DEVELOPMENT ASSESSMENT PANEL REPORT

Application No.	DA/2025/1107
Address	174 Denison Road DULWICH HILL
Proposal	Change of use of an existing residential flat building to a dwelling house, works include partial demolition of existing structures, construction of a new basement, ground floor and first floor addition, in-ground swimming pool and cabana.
Date of Lodgement	18 December 2025
Applicant	The Merita Unit Trust
Owner	Fobitu Pty Ltd
Number of Submissions	Eleven (11)
Cost of works	\$3,384,472.00
Reason for determination at Planning Panel	Number of submissions Impacts to the heritage item
Key Considerations	Loss of affordable housing; heritage impacts; amenity impacts; tree impacts; and matters raised in submissions
Recommendation	Refusal
Attachment A	Reasons for refusal
Attachment B	Conditions of consent in the event of approval
Attachment C	Plans of proposed development
Attachment D	<i>SEPP Housing Report</i>
Attachment E	Statement of Heritage Significance

Figure 8: Tree Location Plan (extract from AIA)

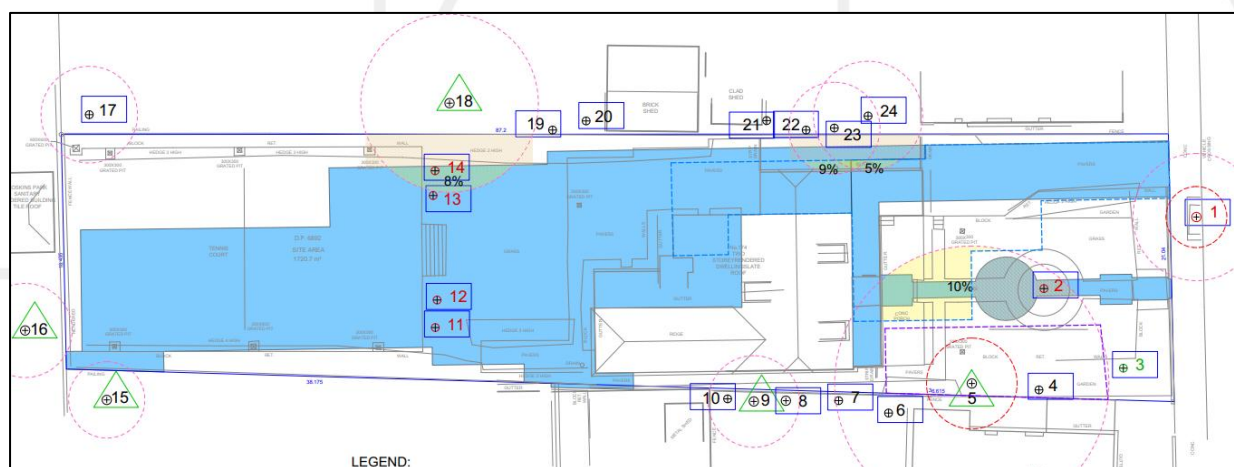
- The landscape is characterised by neat hedging and little tree cover. The only site tree of any substantial size is a *Liquidambar straciflua* (Liquidambar) situated within the front setback. Of the eight existing site trees, five are proposed to be removed and of three remaining trees, one is to be transplanted;

- It is preferable for T2 *Ulmus parvifolia* (Chinese Elm) to be retained as it would not be impacted by the proposed works.
- There is no objection to removal of T11- T14, 4 x *Robinia pseudoacacia* (Black Locust), subject to replacement tree planting; and

- There is no objection to the transplanting of Tree T3.

- T6 *Lophostemon confertus* (Brush Box) and other boundary plantings to the south (the group of *Syzygium* sp. at T7 - T9 at 176 Denison Road is a group of 6 trees). - The NRZ encroachment by excavation for storm water drainage has not been assessed in the AIA;

Given the above, it is considered that insufficient information has been provided to demonstrate that the proposal will not impact the viability of the trees within the site and on neighbouring properties. It is unclear whether modifications to the design of the proposal are required, including changes to the footprint of the building, the location of stormwater drainage and the location and design of retaining walls, to ensure impacts on trees are mitigated.

Figure 10: Extract from Sun Eye Diagram on Drawing DA-70-09-A showing indicative 3D image of proposed driveway with retaining walls to either side and entrance to garage structure

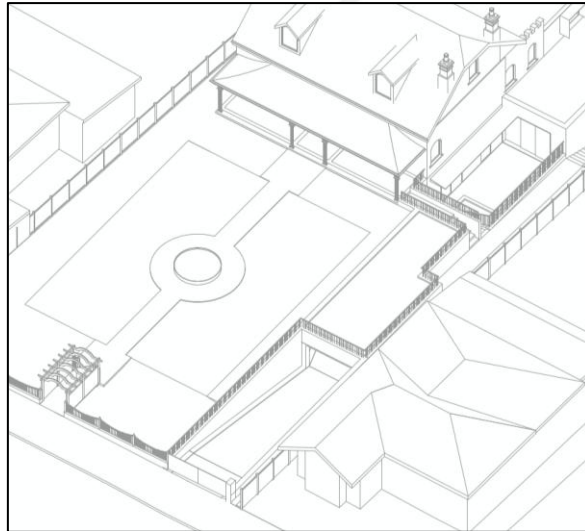
The proposed carparking structure requires a ramped driveway with a slope of 1:4 within the front setback with retaining walls to either side of the driveway. Furthermore, the northwestern wall to the garage and associated fencing above, measures approximately 1.8m above natural ground level at the garage doors and the wall and fencing at the rear of the garage (at the northern corner) measures approximately 2.3m above natural ground level. Figure 10 below, shows an indicative 3D image of the driveway and garage.

While the garage structure is underground towards the southwest it is above natural ground level and expressed to the front elevation (garage door and wall) and side elevation (wall of garage and fence above) along the northeastern boundary. The proposed location of the garage within the front setback is contrary to the controls above.

Figure 12: Indicative 3D image showing scale of new addition -extract from Sun Eye diagram

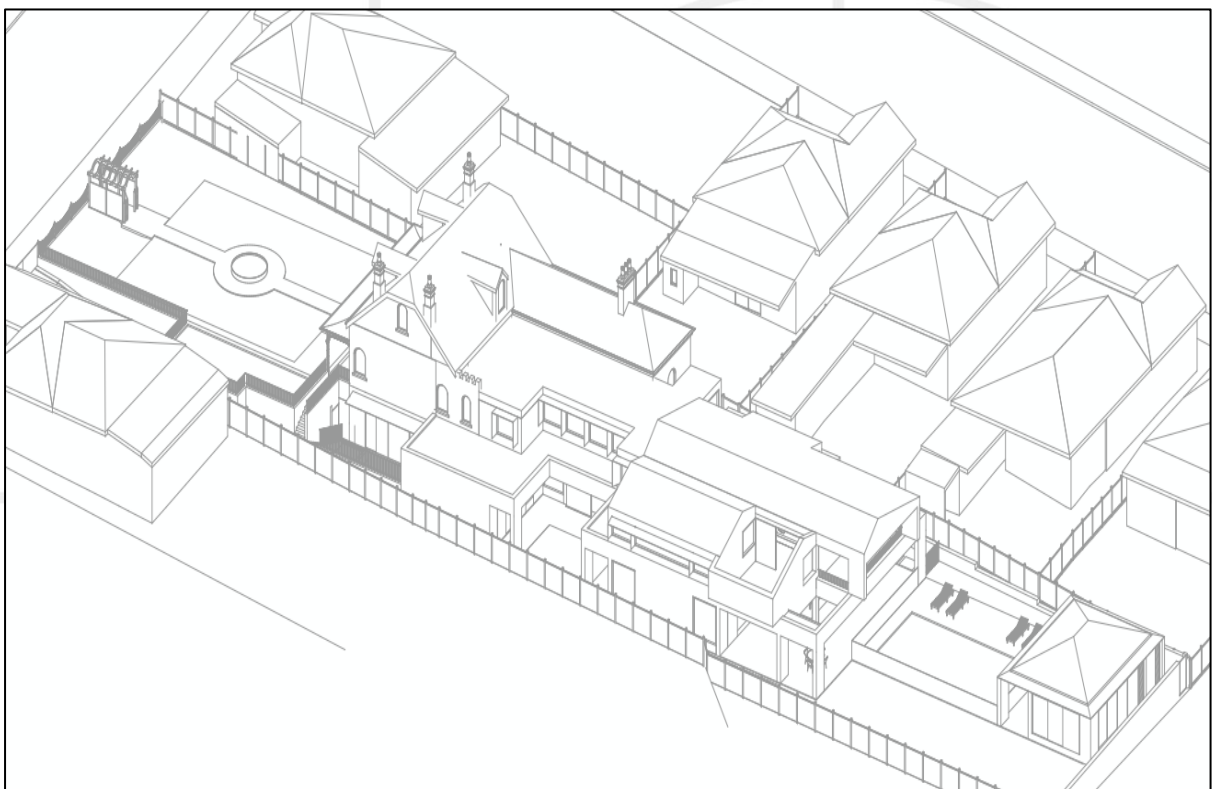
- Contrary to C7, the significant form, scale and proportion of the building has not been maintained due to, among other things, the proposed scale of the addition compared to the existing building and the proposed two storey form that projects into the northeastern setback. Figure 11 below shows the existing subject site and Figure 12 shows the comparative scale of the proposal.

- In principle, a lightweight 'void' that links the existing and new elements can be supported, as it enables the reading of the original building's footprint and external walls and an understanding of the new addition as an entirely separate structure. However, the proposed study attached to the original building itself diminishes this interpretation;

Figure 13: Extract from DA-10-01-A showing the new retaining wall located in the easement

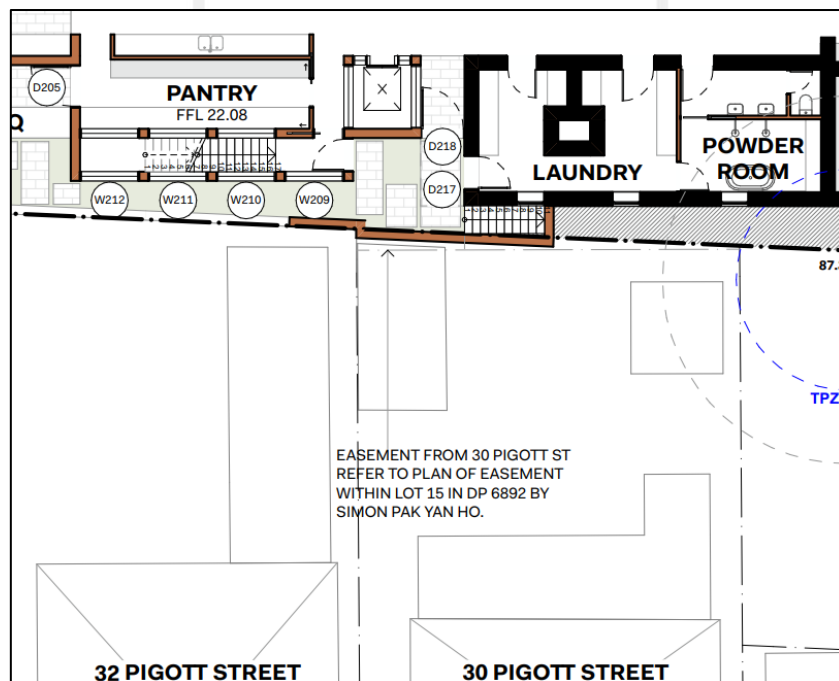
The plans show a new retaining wall, located within the easement from 30 Piggott Street as shown in Figure 13.

Adjoining Land Owners' Consent is required when works are proposed over a property boundary. Adjoining land owners' consent was not submitted.

It is considered that in the event that adjoining land owners' consent could not be obtained and/or it is uncovered that structures cannot be built in the easement, the plans could be amended to delete any works proposed over the property boundaries or in the easement. Any stairs and retaining wall specifically in that location are not considered to be fundamental to the proposal.
